International Isotopes Inc.

Subject: Submittal of Responses to Requests for Additional Information (RAI)
TAC L32739.

The following document is provided as a response to the US Nuclear Regulatory Commission RAIs pertaining to the International Isotopes Fluorine Products Inc. December 30, 2009 application to license a depleted uranium hexafluoride de-conversion and fluorine extraction process facility.

Official Responses to Human Factors RAIs

Figure 4-1 IIFP Facility Human Factors Engineering Design Process

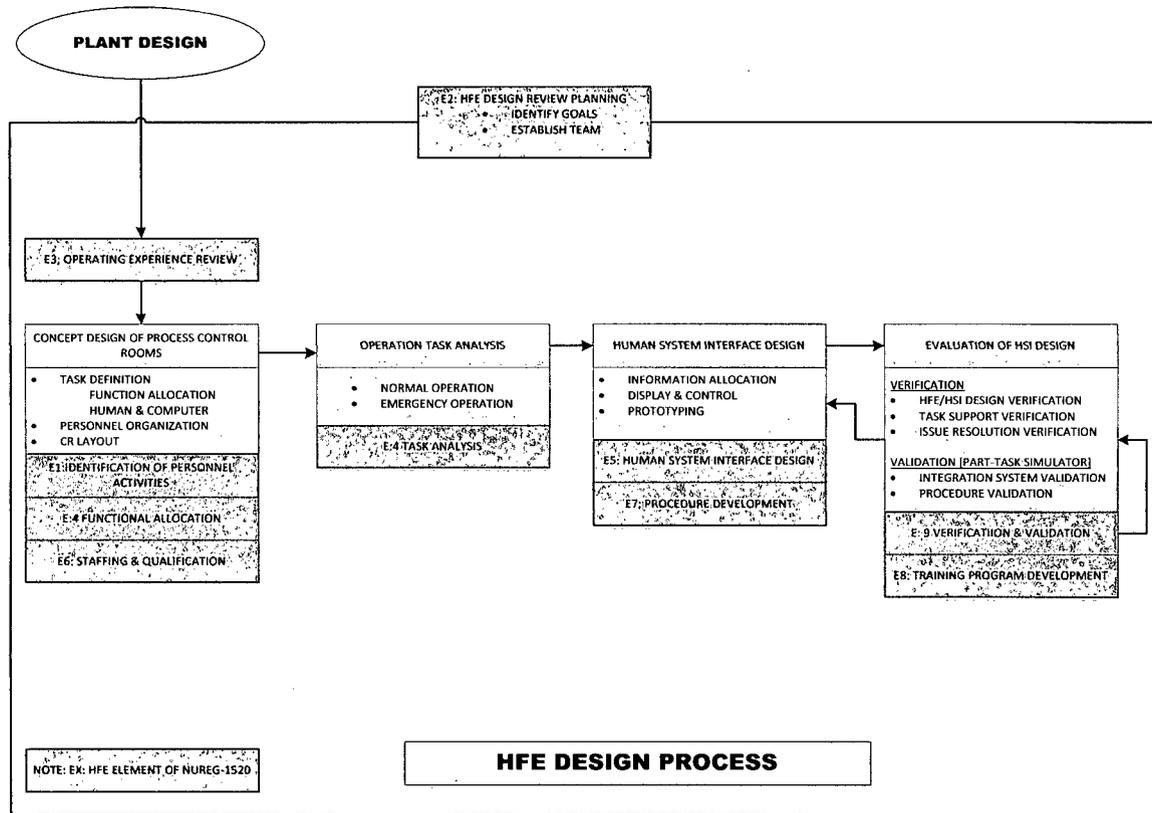
HF-1. Criterion A, Appendix E of NUREG-1520 states that the applicant should appropriately identify the personnel activities that are considered IROFS such that a reviewer can understand the actions, human-system interfaces involved, and the consequences. ISA Table 4-3 contains the Accident Sequence Summary and Risk Index for a number of potential events, many of which are either labeled "operator error" or which appear to involve human action. However, the human-system interfaces involved are not identified.

- a. Identify the human-system interfaces involved in the accident sequences that include human actions, such that the impact on the IROFS can be evaluated.*

License Documentation Impact (2): Renumber ISA Summary Section 4.6 "References" to Section 4.7 "References." Add a new Section 4.6 "Human Factors Engineering and Implementation" to the IIFP ISA Summary to read as follow.

4.6 Human Factors Engineering and Implementation

The HFE design process to be used for the IIFP Facility is depicted in Figure 4-1.
